Project #16-019 Miller Auto Body Addition Located at 50 East 1000 North

Request: Conditional Use & Design Review Permit

Hearing Date April 28, 2016

Submitted By: Russ Holley, Senior Planner

NEW ADDITION

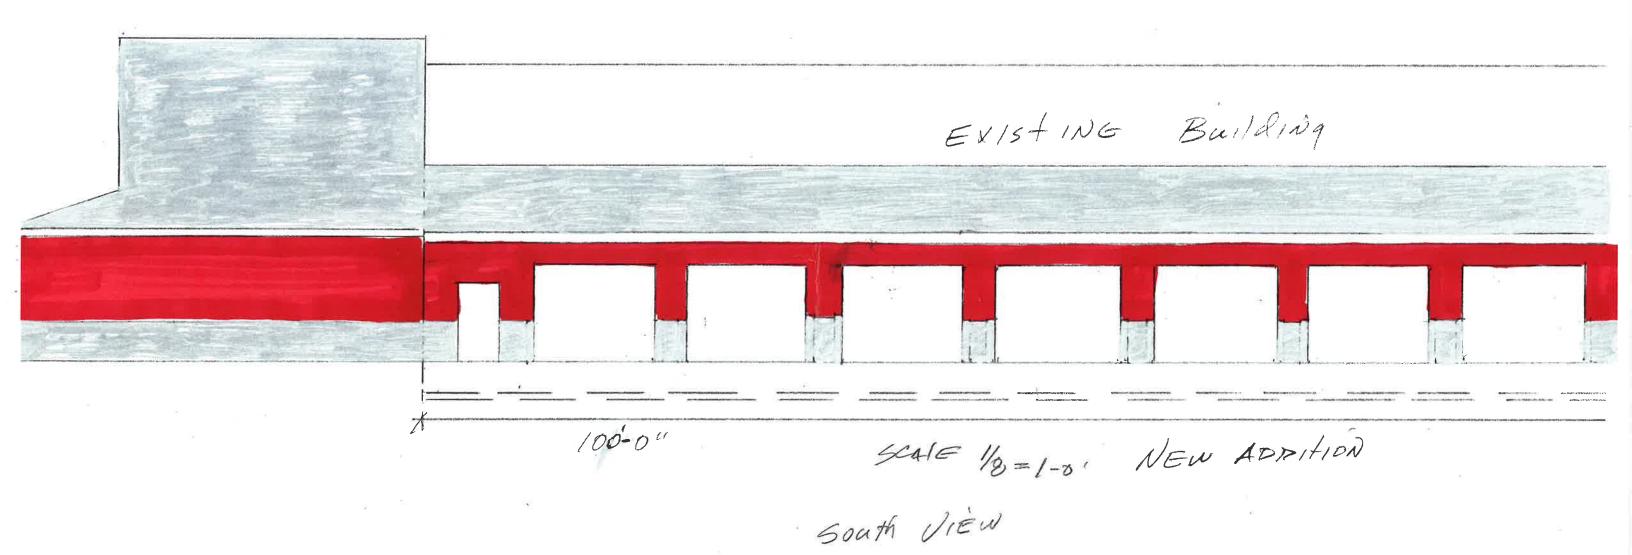
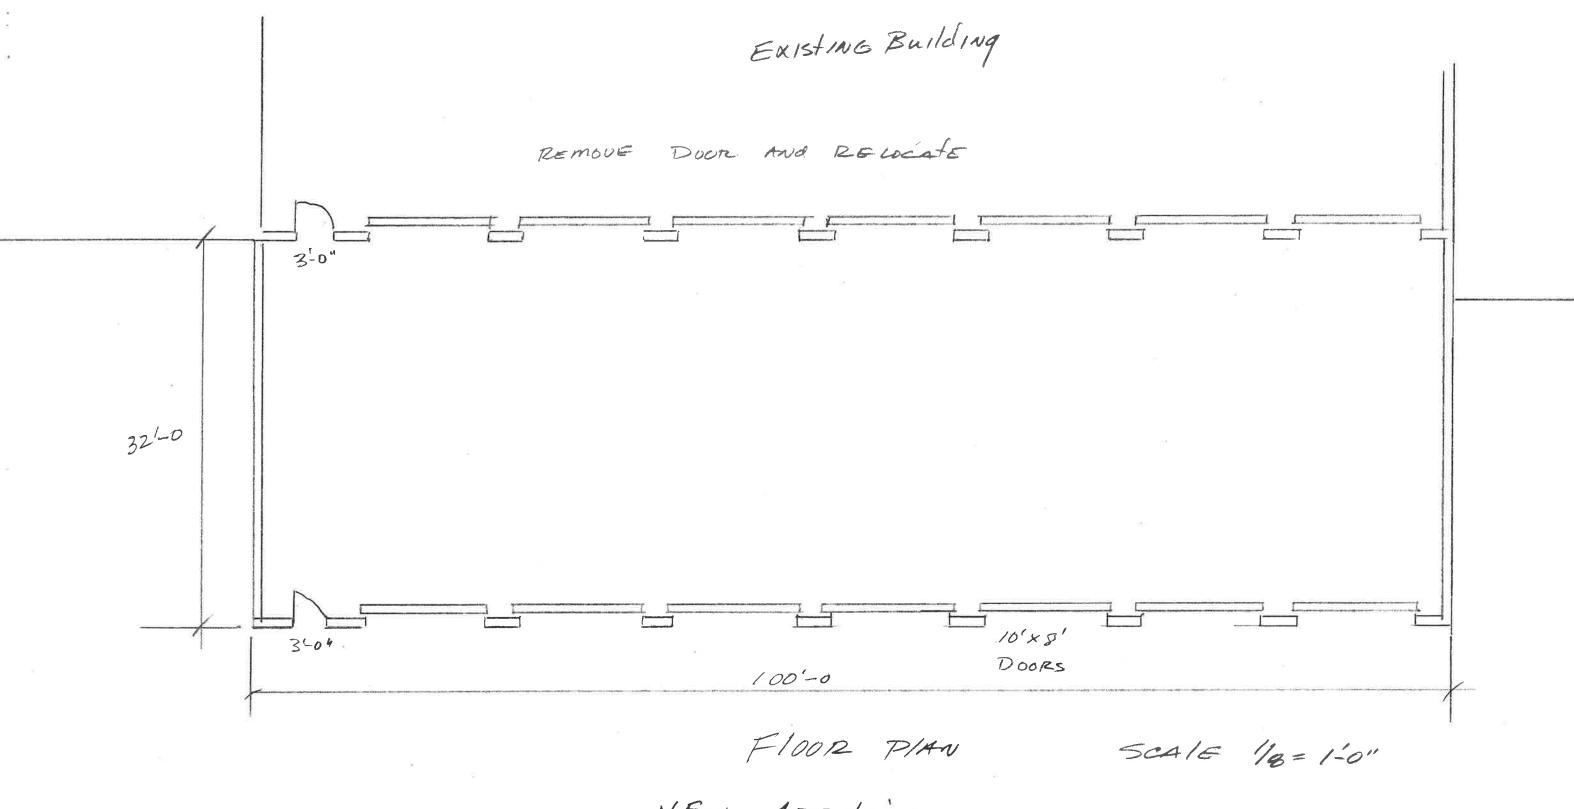
This is a proposal for a new 3,200 SF single-story commercial building addition on a portion of the south façade. The west façade of the addition is proposed at 32' in width. The area is difficult to see from the public street, as it is setback from approximately 255' and behind a

separate parcel with a small building used for car rental/sales. The addition is proposed with a sloped roof and matches the red color and materials of the existing building.

- a. Fire—contact 716-9515
 - Extend fire sprinklers into building addition.
 - b. Water—contact 716-9622
 - If water is to be run into this addition it must have all points of use back flow protection such as air gaps. If this cannot be done because of direct connections then back flow assemblies and or devices must be installed according to hazard rating. Please contact myself for any further assistance.

- If a fire suppression system is required the riser will need a minimum DC (ASSE1015) and tested.
 - If landscaping irrigation is affected by this construction it will need to be brought to today's standards (high hazard) assembly and retested.
